RESOLUTION MSC.222(82)
(adopted on 8 December 2006)
AMENDMENTS TO THE INTERNATIONAL CODE OF SAFETY FOR HIGH-SPEED CRAFT, 2000

AMENDMENTS TO THE INTERNATIONAL CODE OF SAFETY FOR HIGH-SPEED CRAFT, 2000

Figure 2.6.7a

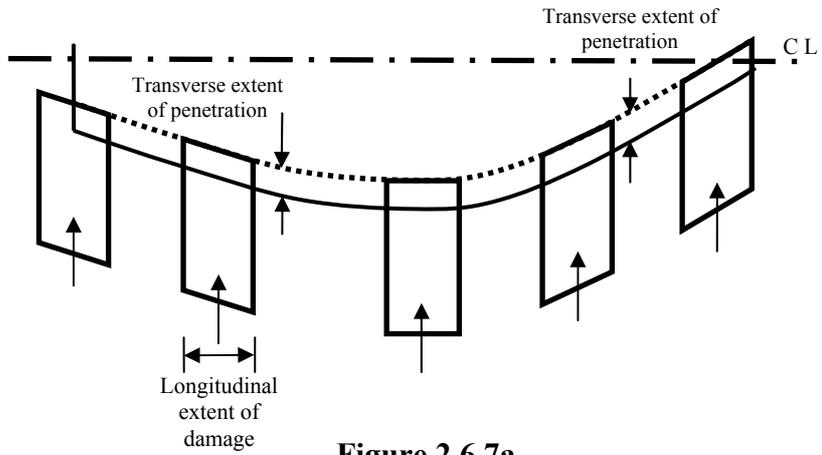
25 The following new section of text is added in continuation of paragraph 2.6.7 after subparagraph 2.6.7.3:

“The damages described in this paragraph shall be assumed to have the shape of a parallelepiped. Applying this to figure 2.6.7a, the inboard face at its mid-length shall be tangential to, or otherwise touching in a least 2 places, the surface corresponding to the specified transverse extent of penetration, as illustrated in figure 2.6.7a.

Figure 2.6.7b

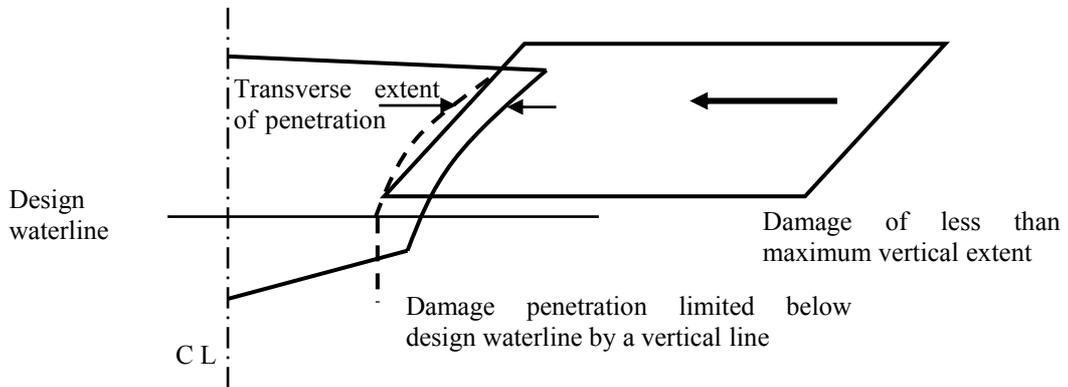
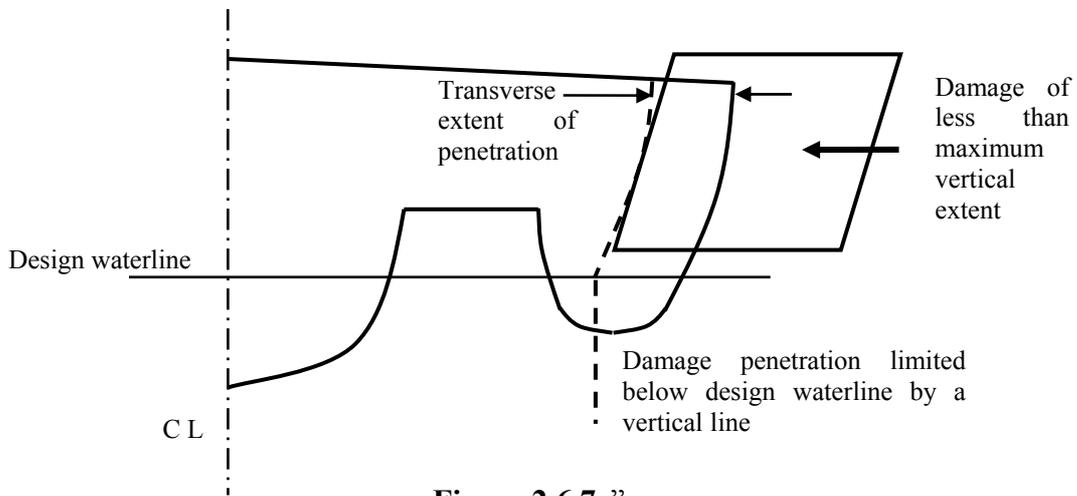
Side damage shall not transversely penetrate a greater distance than the extent of $0.2\nabla^{1/3}$ at the design waterline, except where a lesser extent is provided for in 2.6.7.2. Refer to figures 2.6.7b and 2.6.7c.

If considering a multihull, the periphery of the craft is considered to only be the surface of the shell encompassed by the outboard surface of the outermost hull at any given section.

Figure 2.6.8”

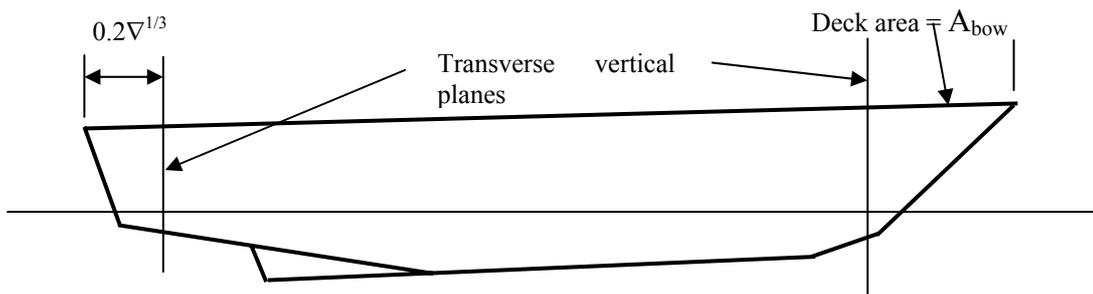
26 Existing paragraphs 2.6.8 to 2.6.12 are renumbered as paragraphs 2.6.9 to 2.6.13 and the following new paragraph 2.6.8 is inserted after the existing paragraph 2.6.7:

“2.6.8 *Extent of bow and stern damage*

2.6.8.1 The following extents of damage are to be applied to bow and stern, as illustrated in figure 2.6.8:

- .1 at the fore end, damage to the area defined as A_{bow} in 4.4.1, the aft limit of which being a transverse vertical plane, provided that this area need not extend further aft from the forward extremity of the craft's watertight envelope than the distance defined in 2.6.7.1; and
- .2 at the aft end, damage to the area aft of a transverse vertical plane at a distance $0.2\nabla^{1/3}$ forward of the aft extremity of the watertight envelope of the hull.

2.6.8.2 The provisions of 2.6.6 in relation to damage of lesser extent remain applicable to such damage.

Figure 2.6.9.2”

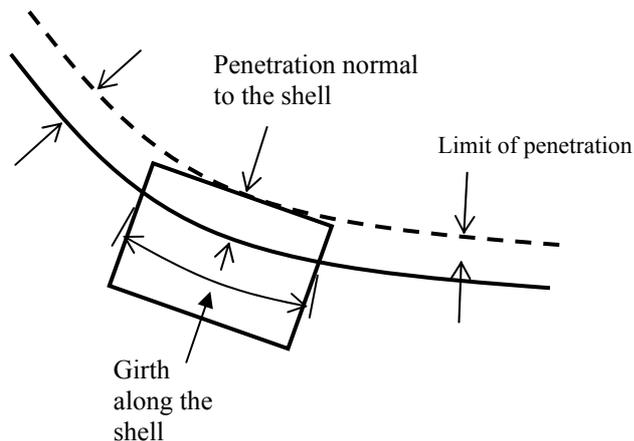
29 The following new paragraph 2.6.9.2.3 is inserted after re-numbered paragraph 2.6.9.2.2:

“2.6.9.2.3 The shape of damage shall be assumed to be rectangular in the transverse plane as illustrated in figure 2.6.9.2 below. Damage is to be assumed at a series of sections within the defined longitudinal extent in accordance with figure 2.6.9.2, the mid-point of the damaged girth being maintained at a constant distance from the centreline throughout that longitudinal extent.

31 In re-numbered paragraph 2.6.10.2, the following new subparagraph .4 is inserted after the existing subparagraph .3:

“.4 the shape of damage shall be assumed to be rectangular in the plane of the shell of the craft, and rectangular in the transverse plane as illustrated in figure 2.6.9.2.”

Figure 7.3.4a

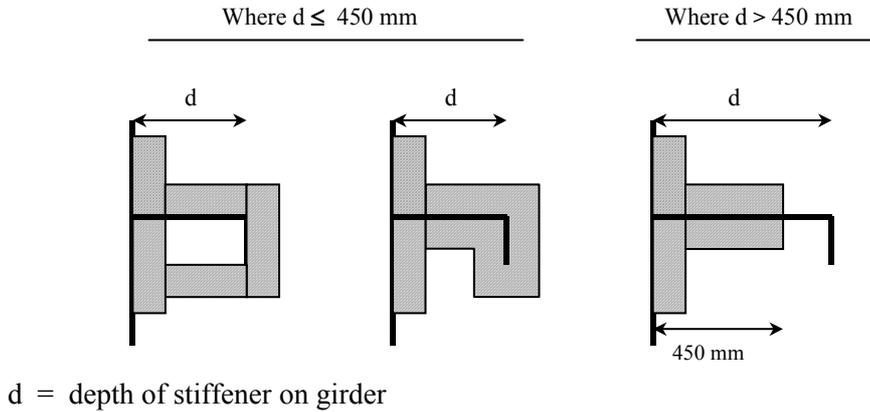
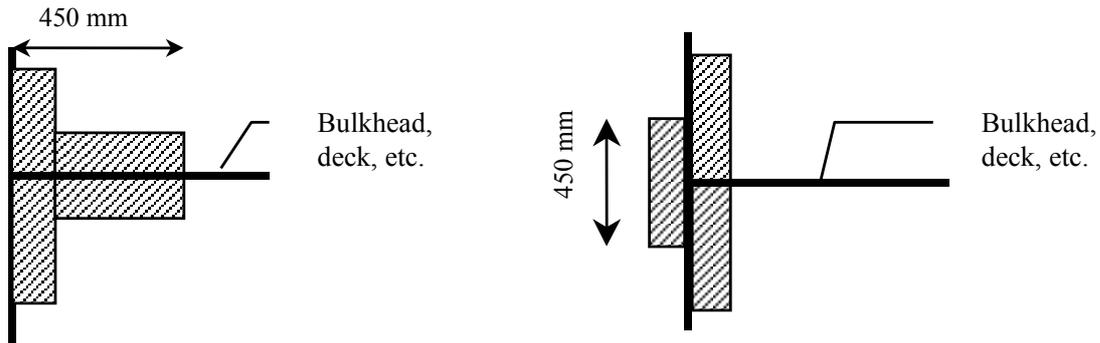
55 The following new paragraphs 7.3.4 to 7.3.6 and associated figures 7.3.4a, 7.3.4b and 7.3.6 are inserted after re-numbered paragraph 7.3.3:

“7.3.4 To prevent heat transmission at intersections and terminal points, the insulation of the deck or bulkhead shall be carried past the intersection or terminal point for a distance of at least 450 mm in the case of steel or aluminium structures (refer to figures 7.3.4a and 7.3.4b).

7.3.5 If a space is divided by a deck or bulkhead and the fire insulation required for each space is different, the insulation with the higher structural fire protection time shall continue on the deck or bulkhead with the insulation of the lesser structural fire protection time for a distance of at least 450 mm beyond the boundary between the spaces.

Figure 7.3.6

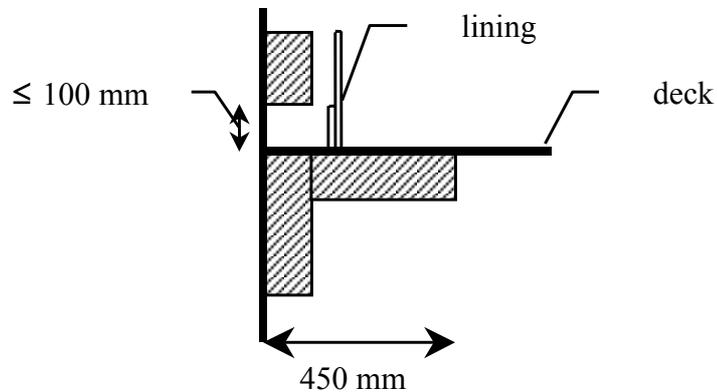
7.3.6 Where the lower part of the fire insulation has to be cut for drainage, the construction shall be in accordance with the structural details shown in figure 7.3.6.
